DESIGN RECOMMENDATION MEETING
WEST DRB: JANUARY 7, 2015

427 9TH AVE N SEATTLE, WASHINGTON
DPD #3016897

# **DESIGN RECOMMENDATION**

## Departure #1 - Minimum Horizontal Dimension of Amenity Area

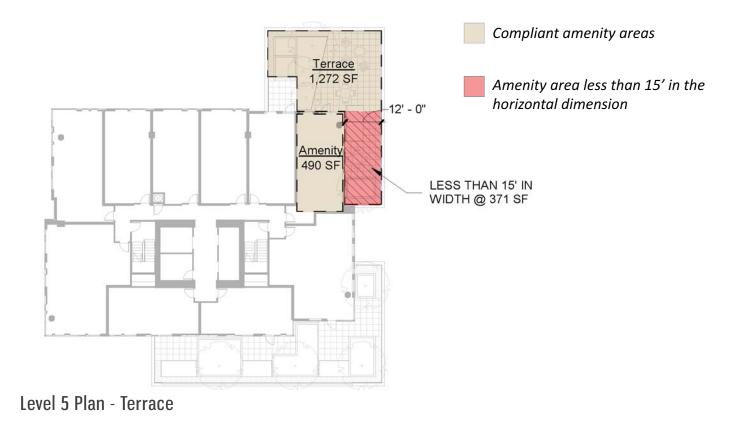
Code: **SMC 23.48.020.C.3** - The minimum horizontal dimension of required amenity area is 15'. The minimum size of a required amenity area is 225 square feet.

Decrease the minimum horizontal dimension of required amenity area at terrace levels. Amenity area between 15' and 10' will constitute 7% of total amenity area. Amenity area under 10' will constitute 3% of total amenity area.

While the vast majority of the required amenity area is compliant, a limited portion will be under the minimum 15' horizontal dimension. At the 5th level terrace, a proposed 12'-wide amenity area provides accessible outdoor space to residents and provides further activation of the upper levels of the 9th Avenue North facade (PL2B1 - Eyes on the Street, DC2D1&2 - Human Scale and Texture). At the rooftop amenity level, the proposed organization and placement of the amenity area supports the overal massing concept for the tower (DC2 - Architectural Concept).

## Departure #2 - Rooftop Features Upper Level Setback

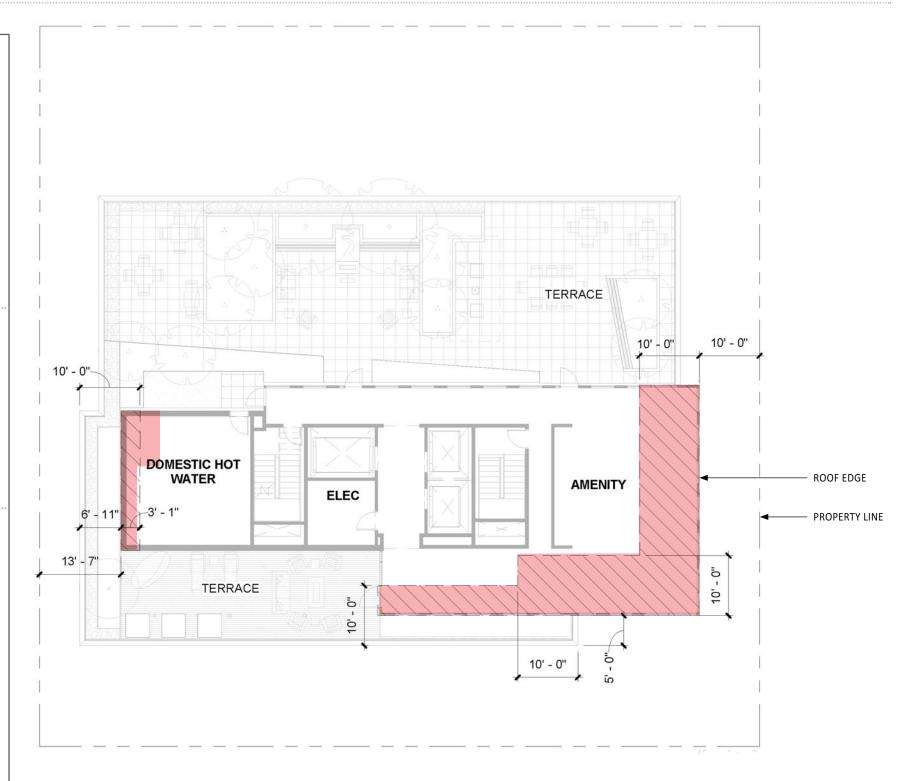
Code: **SMC 23.48.010.H.7** - Rooftop features may extend up to 15' above the maximum height limit, so long as the combined total coverage of all features listed in 23.48.010.H.4 and 23.48.010.H.5 does not exceed 65% of the roof area. No rooftop features are to be located closer than 10' to the roof edge

No setback from roof edges for roof amenity features and mechanical screens.

A 10' setback of the tower massing from the property line will be preserved

The maximum allowable 65% rooftop coverage cannot be attained applying a 10' setback with the proposed floor plate; 55% coverage is the maximum achievable. The proposed alternative maintains the 55% coverage, but elongates the mass east-west, to maximize usable outdoor amenity area along the north and south. The entire tower massing will be setback 10' from the east property line, so that the The alignment along the south edge allows continuity of the tower massing, accentuating the slenderness and verticality of the tower (DC2 - Architectural Concept). A 10' minimum setback of the rooftop features from the property line will be preserved, so that they encroach no further than that of a compliant zero-setback tower.
